Morecambe Offshore Windfarm: Generation Assets Examination Documents

The Applicant's Comments on Written Representations

Document Reference: 9.33

Rev 01

<table><tr> <th rowspan="2">Platform</th> <th colspan="6">Annual Collision Frequency vs Impact Energy</th> </tr></table>

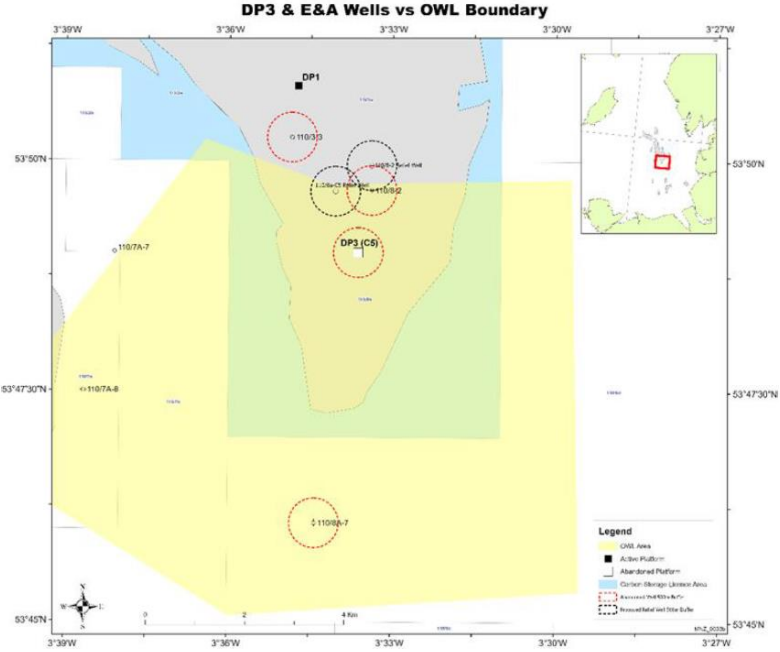
ID	Written Representation	Applicant comment
WR-116-39	<p>In terms of quantifying the collision risk and related mitigation requirements, it is informative to revisit a Vessel Collision Risk Assessment (VCRA) for the East Irish Sea installation located within Morecambe Hub Asset that was carried out by Spirit in 2021. The main objectives of the assessment were as following:</p> <ul style="list-style-type: none"> ▪ Identify the passing merchant vessel activity within 10nm of the installations; ▪ Identify the fishing vessel activity in the vicinity of the installations; ▪ Identify the infield vessel activity associated with the installations; ▪ Estimate the vessel collision frequencies associated with the installations; ▪ Estimate the consequences in terms of impact energy. 	<p>The Applicant notes this response. The Applicant requests that the Vessel Collision Risk Assessment (VCRA) is submitted by Spirit Energy.</p>

WR-116-40	<p>In addition, a review of the effectiveness of Collision Risk Management and REWS system was undertaken together with site-specific inputs for the Morecambe Hub Installations, including the emergency response and rescue vehicle (ERRV) procedures.</p> <p>This identified that an overall collision risk reduction of 64% was estimated, i.e., in 64 out of 100 scenarios, the ERRV will be effective in recovering an errant vessel on a projected collision course.</p>	<p>The Applicant notes this response. The Applicant requests that the VCRA is submitted by Spirit Energy.</p>
WR-116-41	<p>Existing annual passing powered collision frequencies for the Morecambe Hub Installations are noted below. This analysis was undertaken to understand annual collision frequency</p>	<p>The Applicant notes this response.</p>

ID	Written Representation	Applicant comment																																																
	<p>between offshore infrastructure and passing/drifted vessels in order to implement the appropriate collision mitigations by determining the level of risk and support vessels required to minimise this risk. Each offshore installation has an impact energy assessment with the maximum energy the infrastructure can withstand during the collision prior to catastrophic failure (MJ: Megajoules).</p>																																																	
WR-116-42	<p>For the avoidance of doubt, the figures presented in the table are not individual risk to personnel, they are the predicted collision frequency for different vessels for each asset.</p>

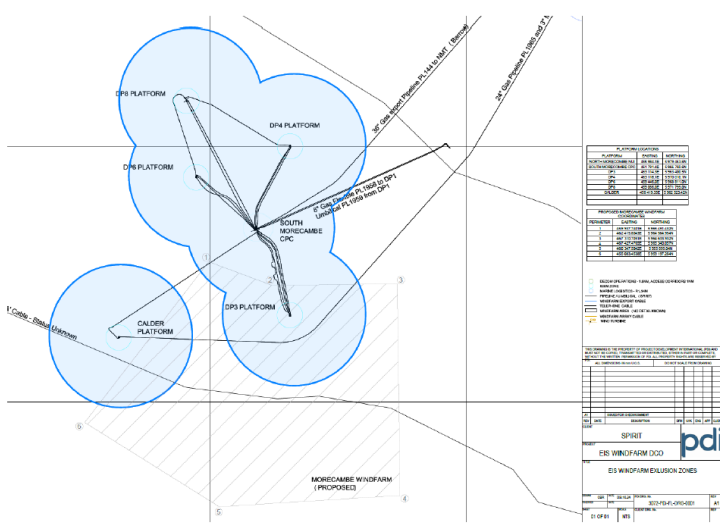
WR-116-83	Pipeline routing – due to the Project, Spirit would require the offshore CO2 pipeline from the carbon source (Peak Cluster) to the MNZ store to be longer. That is because the pipeline cannot be laid via the shortest route to the preferred well location due to access restrictions i.e. not passing through the Project area. The effect of the Project is therefore an increase in the length of the CO2 pipeline with associated increase in capital cost for material, pipeline installation (including cable crossing) duration and associated inspection and maintenance over the lifetime of the pipeline.	The Applicant notes this response.
WR-116-84	Offshore facilities design - the offshore CO2 injection facilities will be located at the well location. The Project has an impact on the well locations which has an effect on the design of the offshore CO2 injection facilities. As a result, Spirit may not be able to proceed with the most optimal location and design of its facilities. The outcome will be increased equipment requirements with associate capital costs. The increase in equipment has two subsequent effects. First, an increased jacket size to support the increase in equipment with associated increase in installation and inspect and	The Applicant notes this response and will provide a detailed comment at Deadline 3.

ID	Written Representation	Applicant comment
	maintenance capital and operational cost. Second, an increased power requirement with associated operational costs.	
WR-116-85	Access to the offshore facilities during installation and operation – a likely option for the location of the offshore CO2 injection facilities is in the vicinity of the manned CPC. The Project has an effect on the access to the existing Central Processing Complex (as identified in the aviation and shipping and navigation sections of the RR and this Written Representation). A CO2 injection facility would be subject to the same or similar limitations and associated consequences.	The Applicant notes this response and will provide a detailed comment at Deadline 3.
WR-116-86	Offshore surveys - to inform the CO2 facilities design and in advance of the submission for the development plan to the OGA, offshore surveys need to be undertaken. These are planned for 2025, 2026 and 2027. Given the location of the Project over the CS010 area, the construction and operations of the Project could significantly limit the access to the area.	<p>The first construction activities are expected to commence towards the end of Q1 2028 with the installation of the foundations for the WTGs and OSPs.</p> <p>This realistic and expected programme is set out in Section 3 of Response to Actions arising from Preliminary Meeting and Issue Specific Hearing 1 (ISH1) (REP1-086).</p>
